ADDENDUM No. 1

ITB No. 4556

2019 Miscellaneous Utility Project

SCALE PLAN: SEE ABOVE
DRAWING No. 2018025-17
SHEET No. 17 OF 31

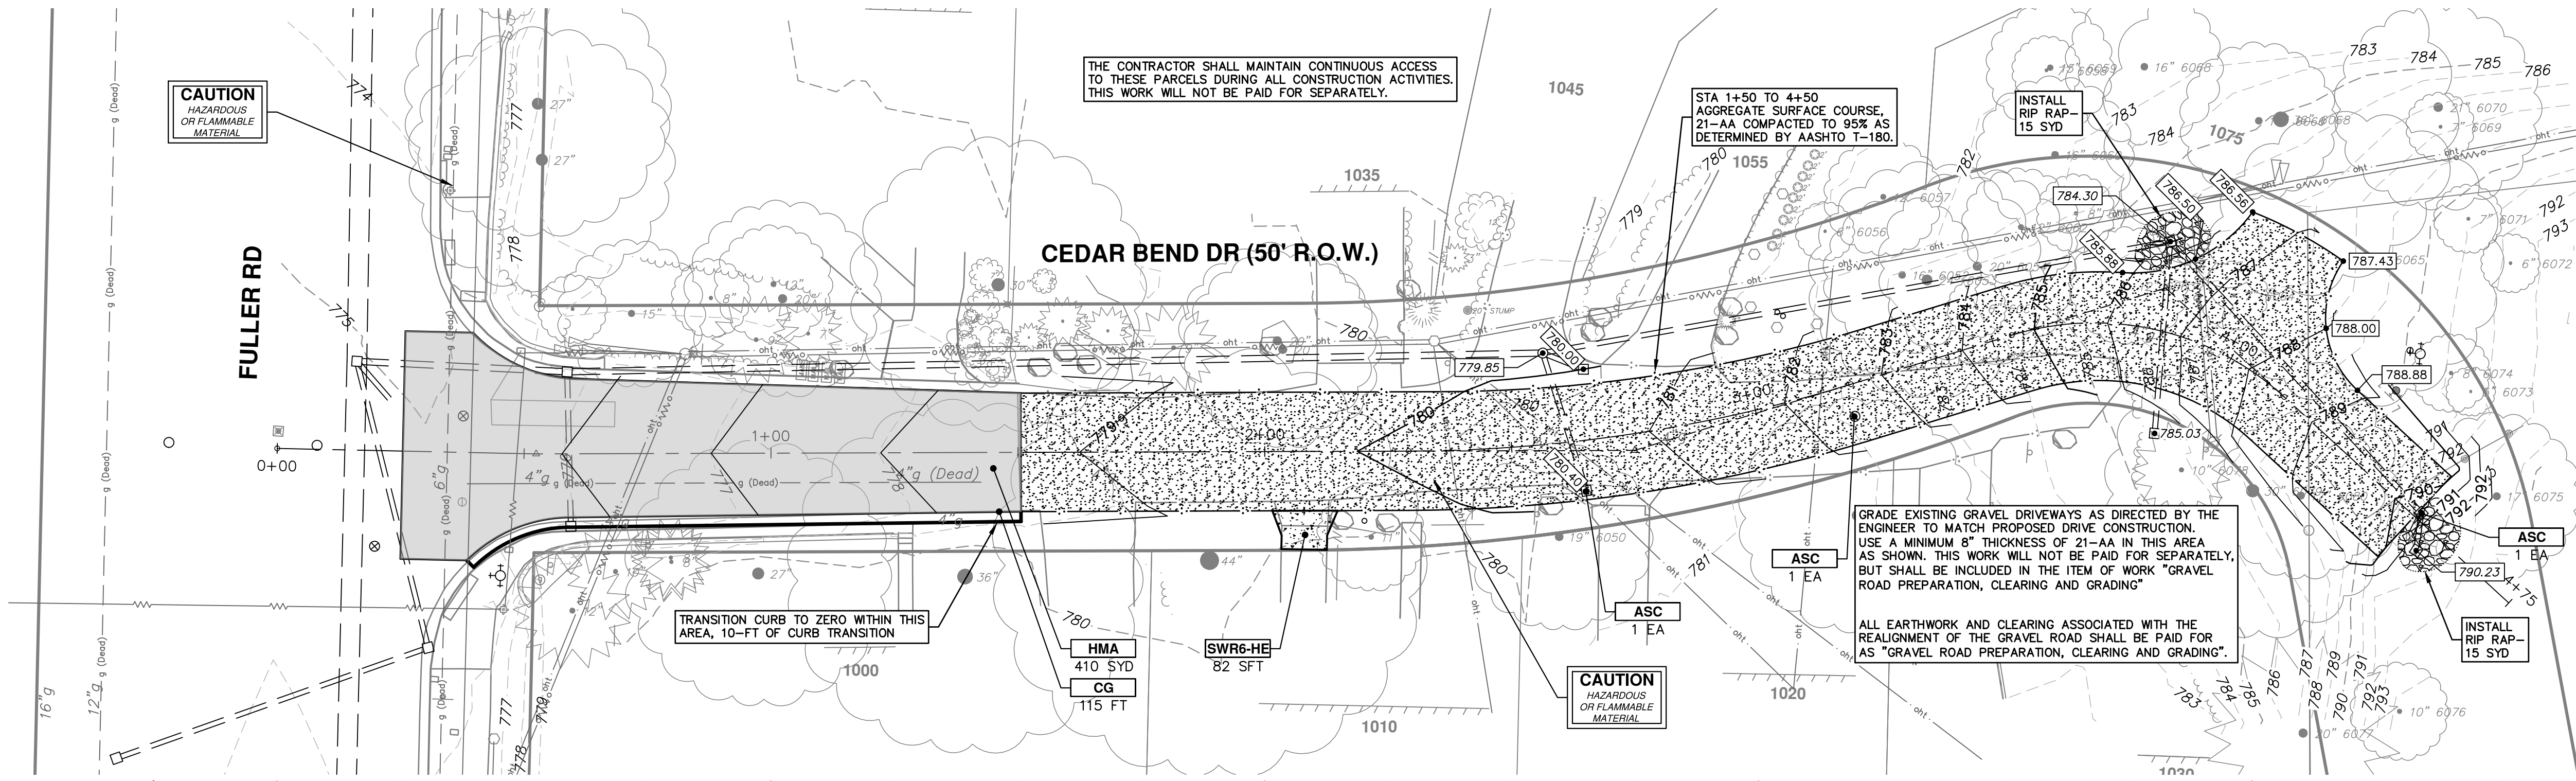
Plan Sheet 17 The note regarding protection of the signal equipment was updated to "contractor to coordinate removal and reinstallation of signal loop detector with City of Ann Arbor Signs & Signals 734-794-6361"
